SUBJECT: TECHNICAL REVIEW: OXIDATION OF REDUCING
CEMENTITIOUS WASTE FORMS, DOCKET NO. PROJ0734

Technical Review: Oxidation of Technetium in Reducing Cementitious Material

June 2015

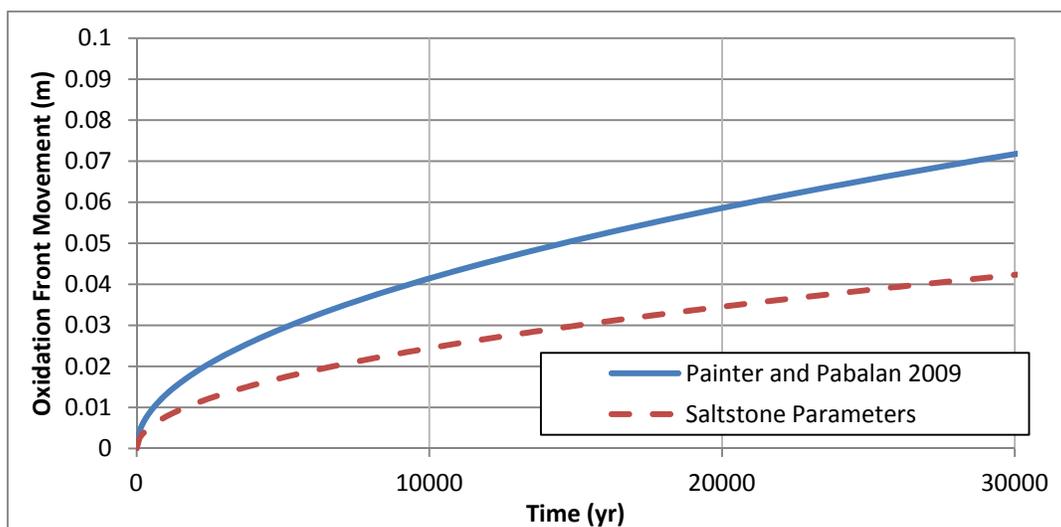
Similarly, the results of the numerical model developed by Painter and Pabalan (2009) demonstrate the importance of gas-phase transport of oxygen in saltstone fractures. As previously discussed, the authors modeled a cementitious material with a significantly lower reducing capacity than saltstone, in addition to differences in density, porosity, and diffusivity. Updating Equation (1), taken from the Painter and Pabalan (2009) study, with parameters more characteristic of saltstone, the equation shows slightly slower oxidation than predicted by Painter and Pabalan (Figure 4). However, the oxidation rates were similar enough that the main conclusion of the Painter and Pabalan study that oxygen from soil gas in unsaturated fractures is a non-negligible source of oxidation is expected to be relevant. Figure 4 is intended to show the relationship between the projections of Painter and Pabalan (2009) and what the projections would be if updated with parameters more relevant to saltstone. NRC staff does not regard Figure 4 as a likely projection of saltstone oxidation because there are several complexities the analytical equation developed by Painter and Pabalan (2009) does not address. These complexities include the following issues:

3. Using the value of $0.607 \text{ meq e}^- / \text{g}$ saltstone for the reducing capacity of saltstone assumes all of the measured reducing capacity in saltstone is in a physical form available to reduce Tc (i.e., not obstructed with a passivating layer).

4. Using the value of $0.607 \text{ meq e}^- / \text{g}$ saltstone assumes the amount of oxidation that occurs in the field during field-scale mixing, pumping, and pouring of saltstone in contact with air is adequately represented by the amount of oxidation that occurred during laboratory-scale mixing and pouring of saltstone samples.

The NRC staff is not aware of studies specifically designed to quantify oxidation that occurs as saltstone is mixed, pumped, and poured in contact with air. DOE has plans to measure Tc leaching from cored samples of field-emplaced saltstone. Comparing leaching from field-emplaced saltstone and laboratory-created samples may capture some effects of oxidation during field emplacement if the cores are partially oxidized. However, reducing capacity is more likely to affect the duration of reducing conditions than it is to affect Tc leaching from areas that remain reducing. Because the oxidation state of a redox couple depends on the Eh of solution, and not the reducing capacity, Tc leaching is not necessarily a good indication of whether some, but not all, of the reducing capacity in a region of saltstone has been consumed. Thus it is not clear whether measurements of Tc leaching from reduced regions of saltstone will adequately support conclusions about how much reducing capacity is consumed by mixing, pumping, and pouring saltstone in contact with air. Because the reducing capacity is a chemical barrier to oxygen ingress, studies that evaluate the progress of an oxidation front could provide information about the effective reducing capacity of field-emplaced samples. Measurements of reducing capacity also could be useful, if they address the uncertainties related to reducing capacity discussed in this review.

In addition to the limitations of the projections of Painter and Pabalan (2009) discussed above, a more fundamental limitation exists if Tc leaching is not well correlated to residual reducing capacity. This question is discussed further in the evaluation of Question 4.
